LOCKED ROTOR ANALYSIS (TAR-878)

Plant Name:	Oconee, Units 1 & 2
Docket Nos.:	50-269 & 50-270
Licensing Stage:	Post-OL
Responsible Branch	LWR 2-3
and Project Manager:	I. Peltier
Technical Review Branch Involved:	Core Performance Branch
Requested Completion Date:	May 1, 1974
Description of Review:	Reanalysis of Locked Rotor Accident

SUMMARY OF EVALUATION

Figure 1

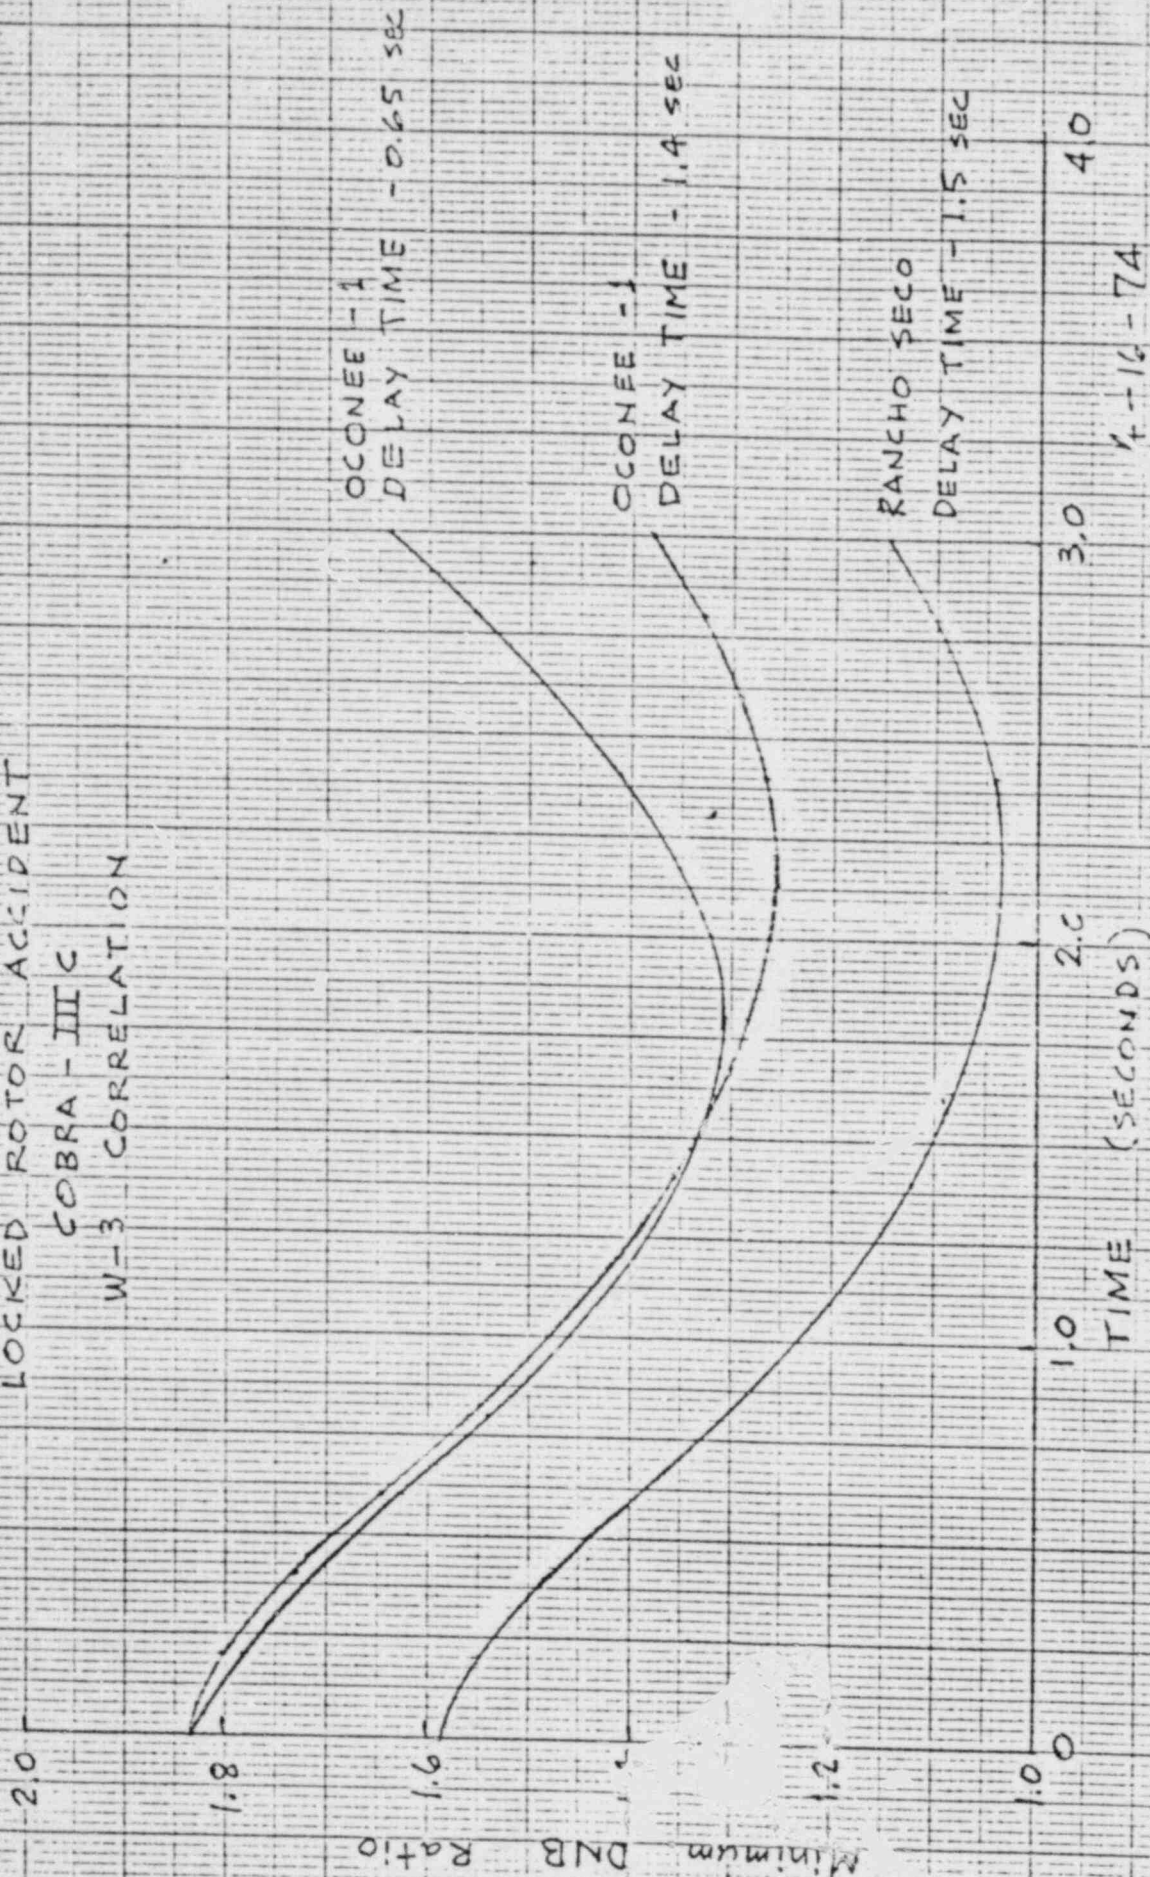
<u>MINIMUM DNB RATIO</u>							
Delay Time (sec)	<u>Oconee 1/2</u>			Delay Time (sec)	<u>Rancho Seco</u>		
	W-3	BAW-2	FSAR		W-3	BAW-2	FSAR
0.65	1.305	1.655	1.15	0.75	1.075	-	1.0
1.40	1.257	1.537	-	1.50	1.031	1.262	-

The effect of the delay time change on Oconee 1/2 is illustrated in the enclosed Figure 1, using the W-3 correlation for determination of DNB. The DNBR transient for Rancho Seco with an assumed delay time of 1.5 seconds is also presented.

We find that the locked rotor accident analysis as presented in the Oconee 1/2 FSAR still acceptable under the proposed Tech Spec change in flux/flow trip delay time. This conclusion is also reached for the other B&W plants considered in this evaluation.
